TRANS/WP.29/2000/62  
25 August 2000

PROPOSAL FOR DRAFT 01 SERIES OF AMENDMENTS TO REGULATION No. 96

(Emissions of agricultural and forestry tractors)

Transmitted by the Working Party on Pollution and Energy (GRPE)

Model A

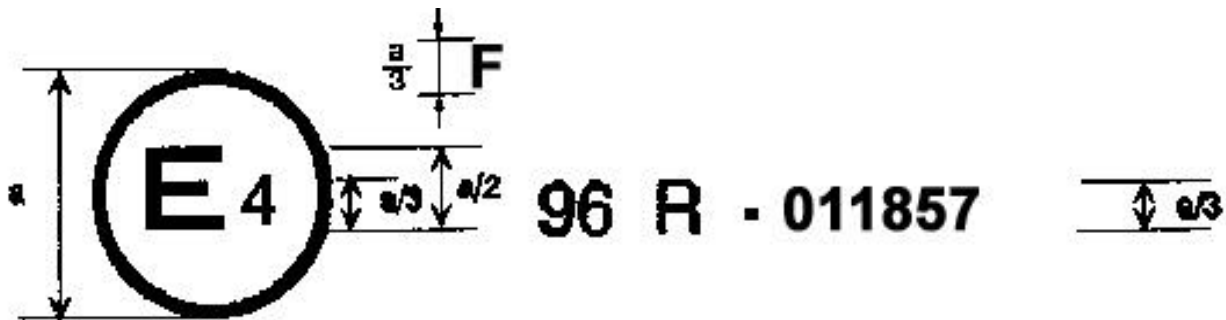
Annex 3, amend to read:

The above approval mark affixed to an engine shows that the engine type concerned has been approved in the Netherlands (E4) pursuant to Regulation No. 96 (according to the level corresponding to power band F) and under approval number 011857. The first two digits of the approval number indicate that Regulation No. 96 was in its amended form (01 series of amendments) when the approval was granted.

Model B

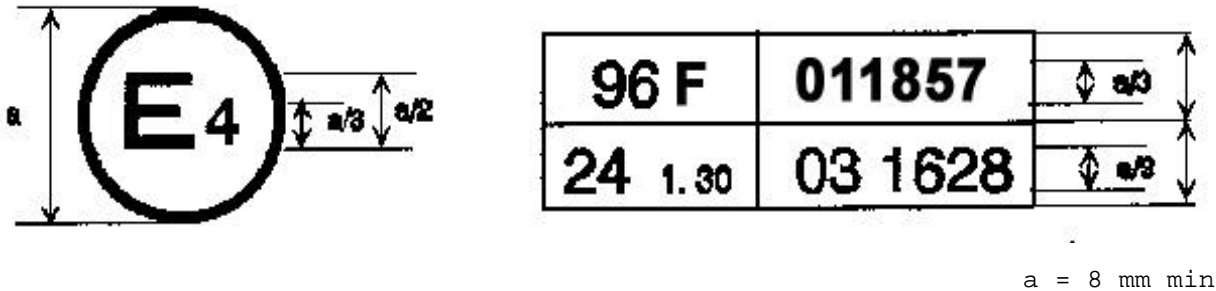
The above approval mark affixed to an engine shows that the engine type concerned has been approved in the Netherlands (E4) pursuant to Regulations Nos. 96 (according to the level corresponding to power band F) and 24. The first two digits of the approval number indicate that, at the dates when the respective approvals were granted, Regulation No. 96 was already in its amended form (01 series of amendments) and Regulation No. 24 already included the 03 series of amendments."
